Access Compliance Report

Public Rights-of-Way

(Curb Ramps)

Intersection ID: 11483	Main Street: E_17TH_ST	Cross Street: N_CALDWELL_ST	Location: W
ADA ID: 4D7982470D2E	Ramp Type: PerpDiag	Initial Pass/Fail: Fail	Overall Compliance: No
Severity Score: 25			
Codes/Mitigation Info/Possible Solution		Field Measurements/Component Compliance

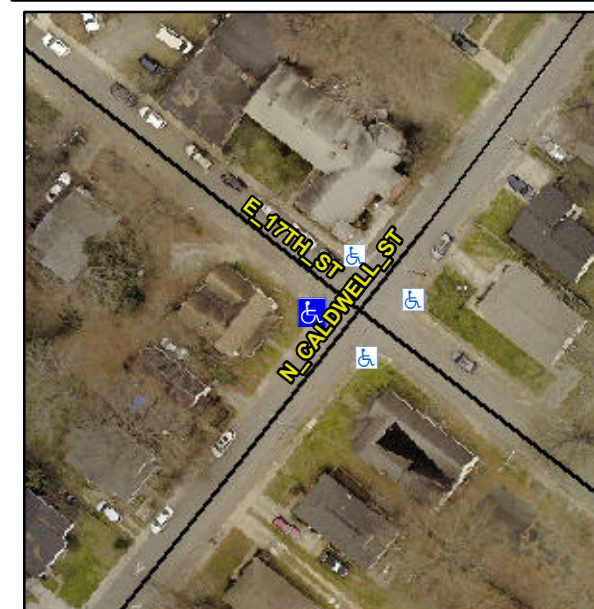
Not Found, R304.2.2

Compliance	Description	Data	Compliance	Description	Data
N/A	Ramp Length (in)	53.0	No	Ramp Slope (%)	20.0
Yes	Ramp Width (in)	48.0	Yes	Ramp XSlope (%)	2.0
N/A	Flare Type LT	N/A	N/A	Flare Type RT	N/A
N/A	Flare Slope LT (%)	N/A	N/A	Flare Slope RT (%)	N/A
N/A	Flare Traversable LT?	N/A	N/A	Flare Traversable RT?	N/A
N/A	Landing Length (in)	N/A	N/A	DWS Provided?	N/A
N/A	Landing Width (in)	N/A	N/A	DWS Contrast?	N/A
N/A	Landing Slope (%)	N/A	N/A	DWS Length (in)	N/A
N/A	Landing X Slope (%)	N/A	N/A	DWS Full Width?	N/A
N/A	Landing Curb? (Y/N)	N/A	N/A	DWS Offset (in)	N/A
N/A	Shared Landing?	N/A			
N/A	Gutter Ponding?	Yes	N/A	Gutter Slope (%)	N/A
N/A	Gutter Lip Ht (in)	N/A	N/A	Gutter X Slope (%)	N/A
N/A	Painted X Walk1?	No	N/A	Painted X Walk2?	No
	X Walk 1 Direction	To SE		X Walk 2 Direction	To NE
N/A	X Walk 1 Width (in)	N/A	N/A	X Walk 2 Width (in)	N/A
	X Walk 1 Slope (%)	5.4		X Walk 2 Slope (%)	6.5
	X Walk 1 X Slope (%)	1.3		X Walk 2 X Slope (%)	2.4

Remove & Replace Curb Ramp With Two New Directional Ramps or Equivalent.
